# **BOARD OF ARCHITECTURAL REVIEW - LARGE**

January 22, 2020

573 MEETING STREET  
TMS # 463-16-04-022

Request conceptual approval for renovation of existing building into a restaurant.

SITE PLAN -  
COMPARISON

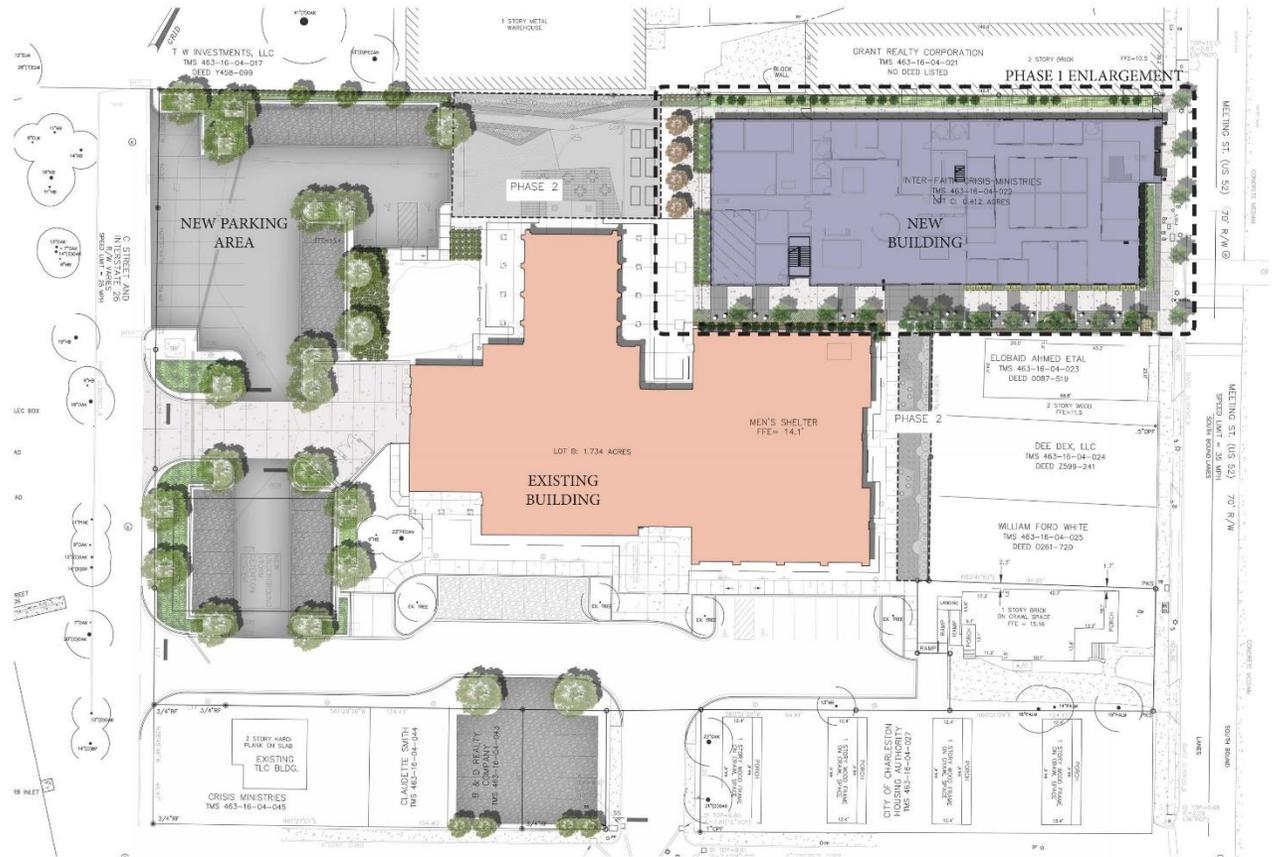
CONCEPTUAL BAR COMMENTS (11/14/2018)

STAFF COMMENTS:

- STUDY A WAY TO BREAK UP THE LONG MASS OF THE N. ELEVATION
  - PORTION OF BUILDING HAS BEEN RECESSED FROM FLOORS 3-7
- THE BRICK OF THE 3-STORY MASS FEELS MORE LIKE A SURFACE TREATMENT THAN A SUBSTANTIAL MASONRY MATERIAL. IN PART DUE TO THE DIMENSION FROM THE FACE OF BRICK TO STUCCO. CONSIDER AN ALTERNATE MATERIAL OR INCREASE IN THE DEPTH OF BRICK, WHICH WOULD HELP THE WINDOWS TO BE SET DEEPER

- ALSO, THE THIN COLUMNS VISUALLY SUPPORTING THE MASS ABOVE IS UNCOMFORTABLE AND SHOULD BE RESTUDIED
  - HEIGHT OF MASS ABOVE THE SIDEWALK HAS BEEN LOWERED AND THE COLUMNS HAVE BEEN REMOVED

- INFILLED AREAS HAVE BEEN REMOVED AND REPLACED WITH METAL PANEL TO MATCH WALL
- PROVIDE INFORMATION FOR THE FENCE BETWEEN 573 AND 575 MEETING.
  - FENCE IS NOT REQUIRED PER ZONING AND HAS THEREFORE BEEN REMOVED AND REPLACED WITH LANDSCAPE

BOARD COMMENTS:

1. BREAK UP THE NORTH ELEVATION
2. USE MATERIAL OTHER THAN FIBER CEMENT
3. TRY TO BETTER HIDE V-TAC LOUVERS NOT BEHIND SCREEN
4. ENTIRE 3-STORY FACADE ON MEETING ST. COULD BE BRICK
5. COLUMNS ON EAST AND SOUTH ARE TOO SLENDER
6. BUTTERFLY ROOF IS A DEFINING ELEMENT AND SHOULD BE MORE BOLD AND BETTER DETAILED

**PREVIOUS DESIGN - PRELIMINARY BAR: (DEC. 2, 2019)**

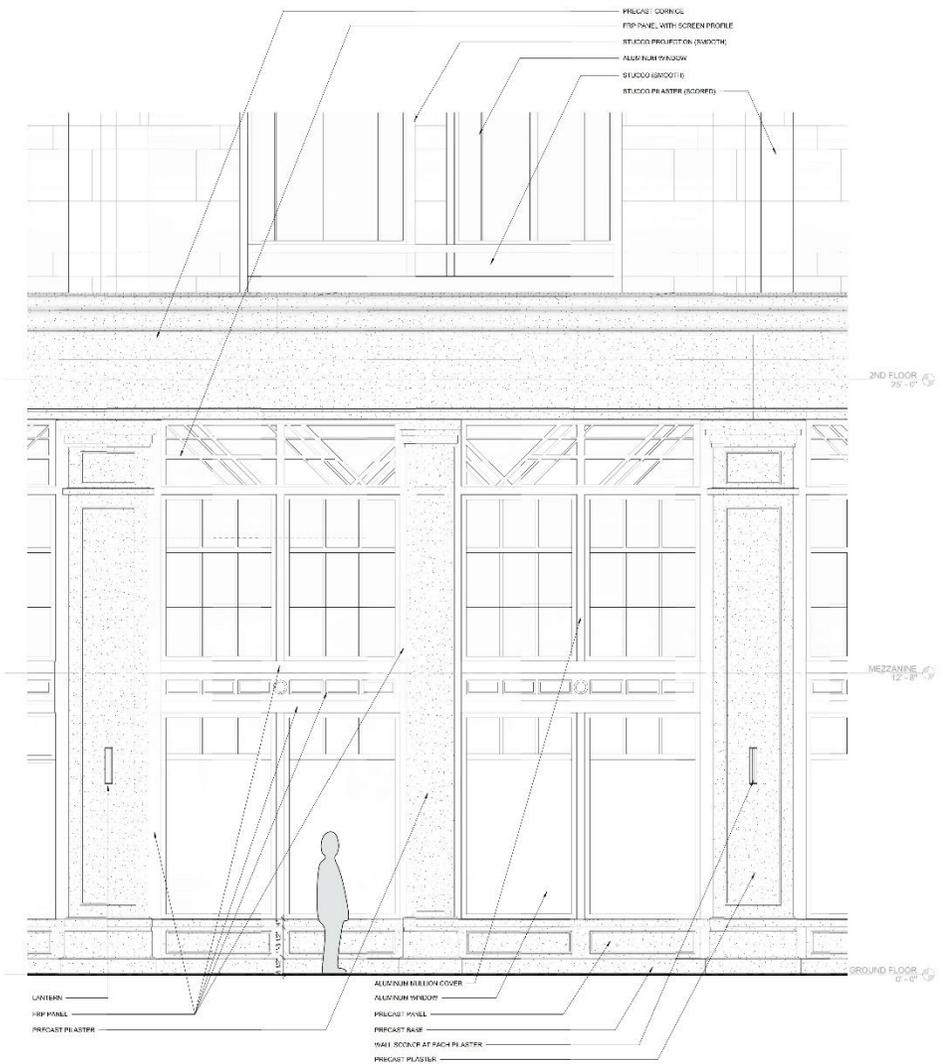
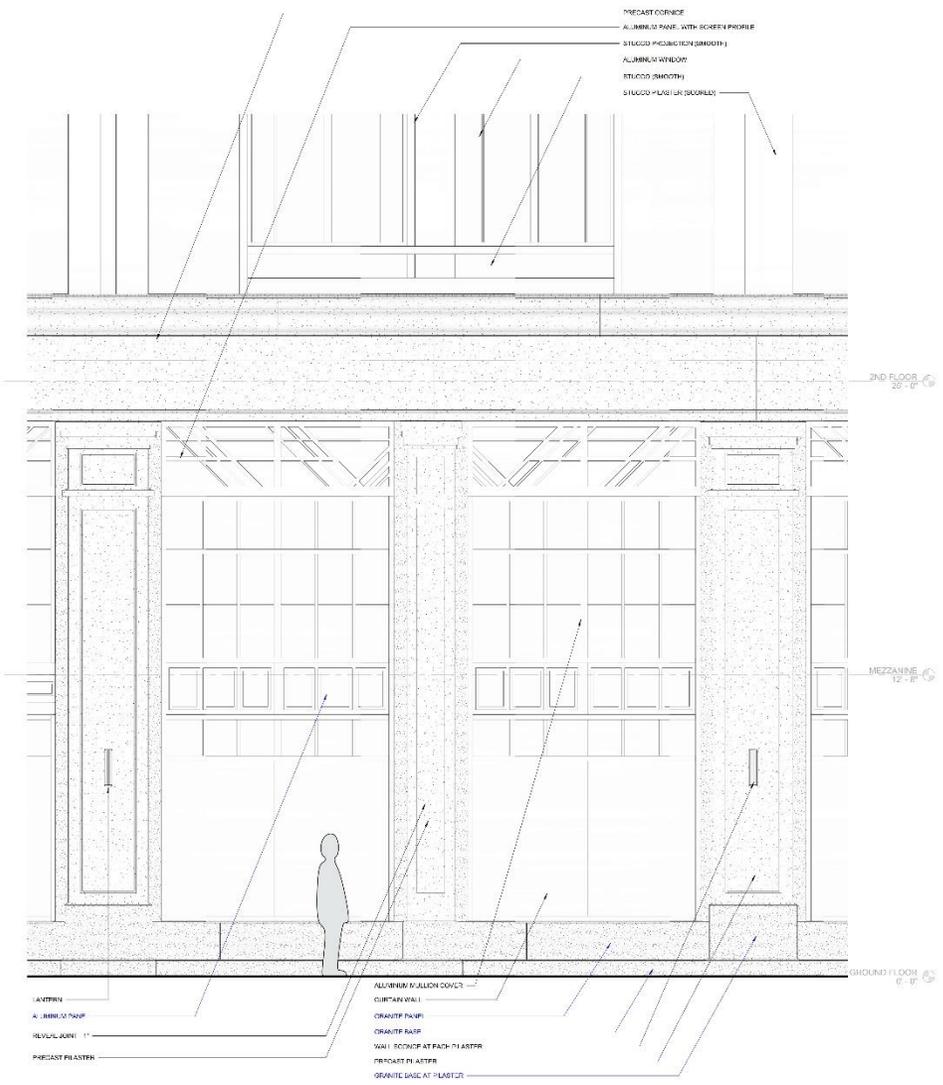
KEY BOARD COMMENTS FROM PRELIMINARY BAR (DEC. 2ND)

11. Materials need to be upgraded as follows:
  - a. The base of the building up to the 2nd level cornice needs to be actual stone per the "principles".
  - b. There is a lot of FRP (plastic product) proposed for the building such as at balconies, brackets, canopies, cornices, panels, headers, recesses etc. This is contrary to the Board's directive on other large projects and should be upgraded and limited to the highest portions of the building if used at all.
  - c. Thermochromex stucco is an upgrade but must be resolved with the scored stucco and control joints.

1. A granite watertable has been added at the base of the building.
2. All instances of FRP have been replaced with either GFRC or Aluminum Panel
3. The scored stucco joints have been removed.

TYPICAL LIGHT AT PILSTERS

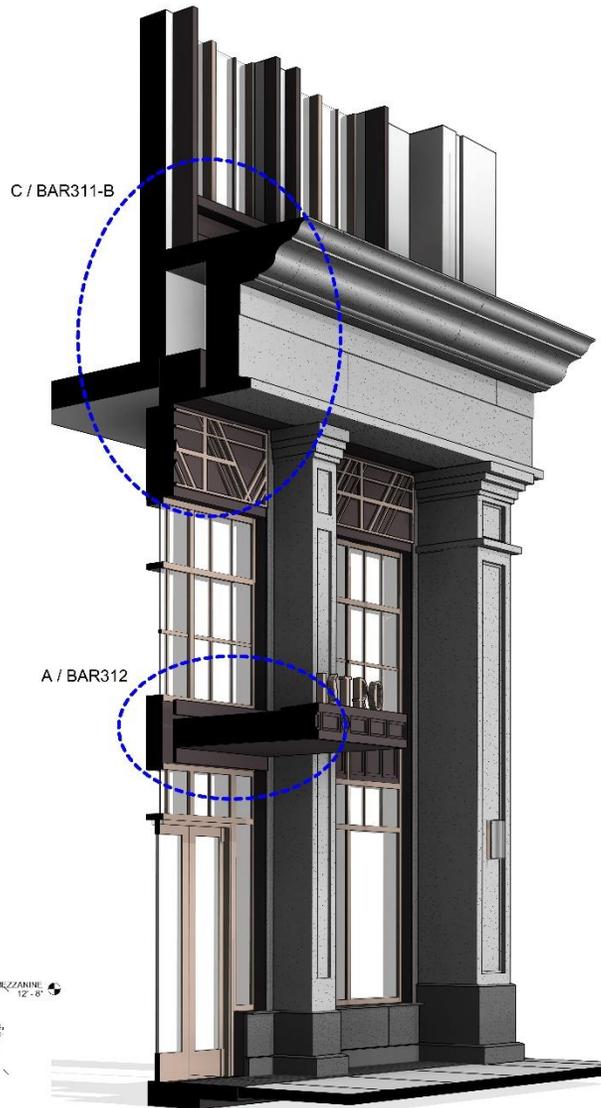
9. **Reduce number of light fixtures to not every pilaster.**  
*Response: We disagree with this comment. The repetitive 'bay' architecture creates an armature that is appropriate for repetitive lighting. This helps activate the streetscape and provide light in what is otherwise a dark area. The lights are spaced approximately 27' on Meeting and Morrison Streets. The typical bay width of historic buildings on King and Meeting Streets is 26'. Therefore the light spacing shown is appropriate.*

DETAILS AT GLASS COLUMNS BAR313C

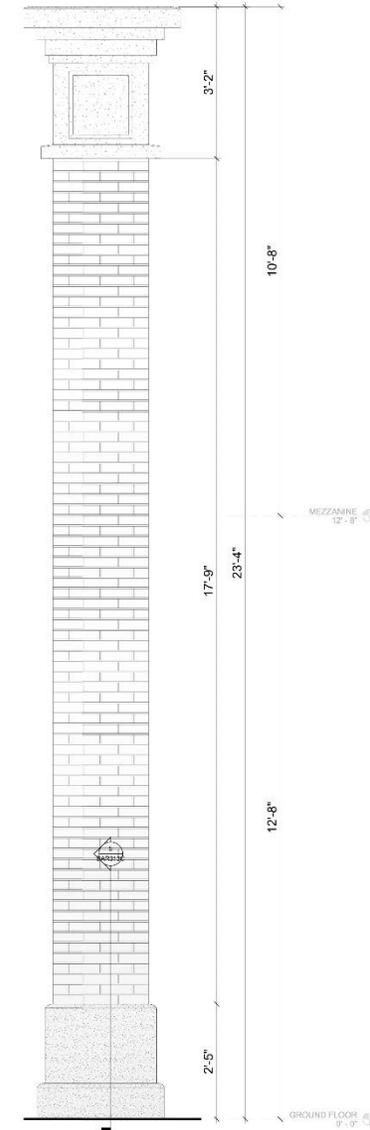
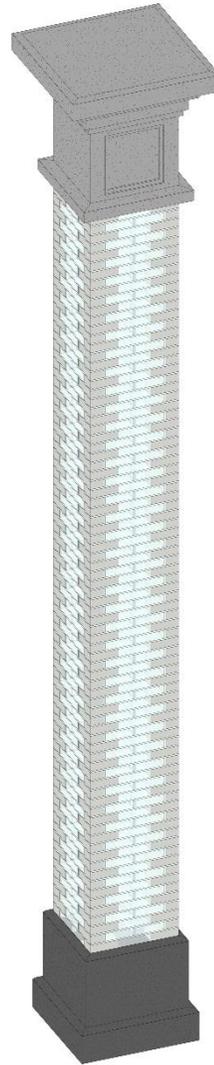
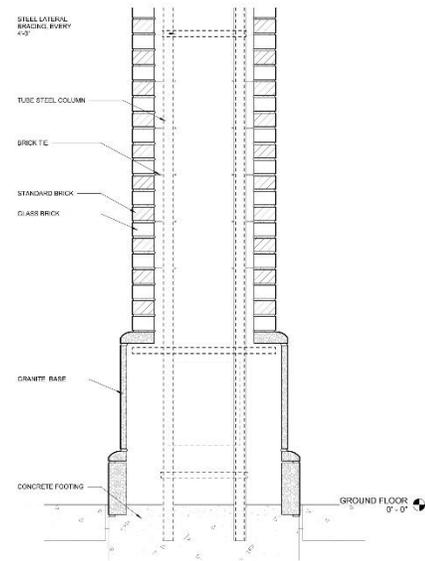
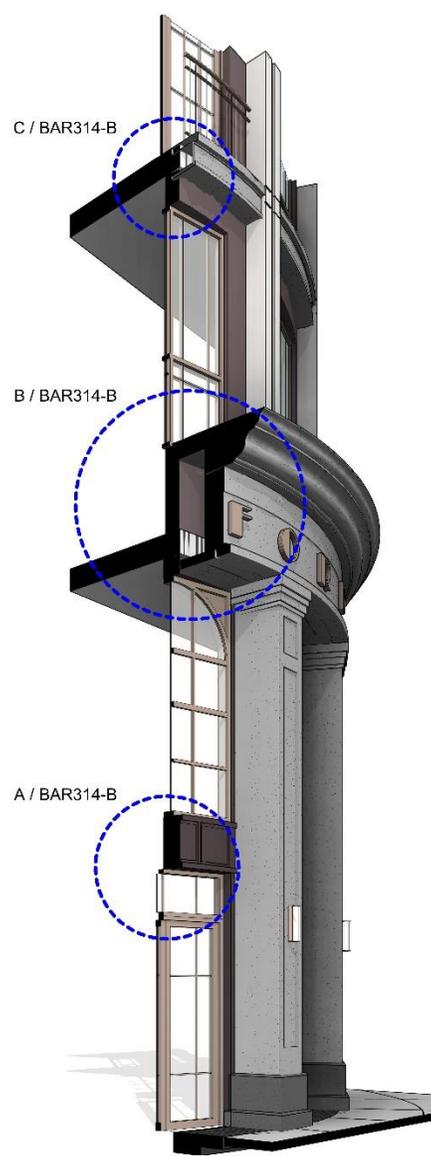
8. **Rope lighting in glass brick columns must be eliminated shown on 2/BAR313C. (assured they would not be lit last review). This is contrary to Board policy, reserved for civic buildings per the "Principles", and not a good precedent.**  
*Response: The lighting has been removed from the glass columns.*
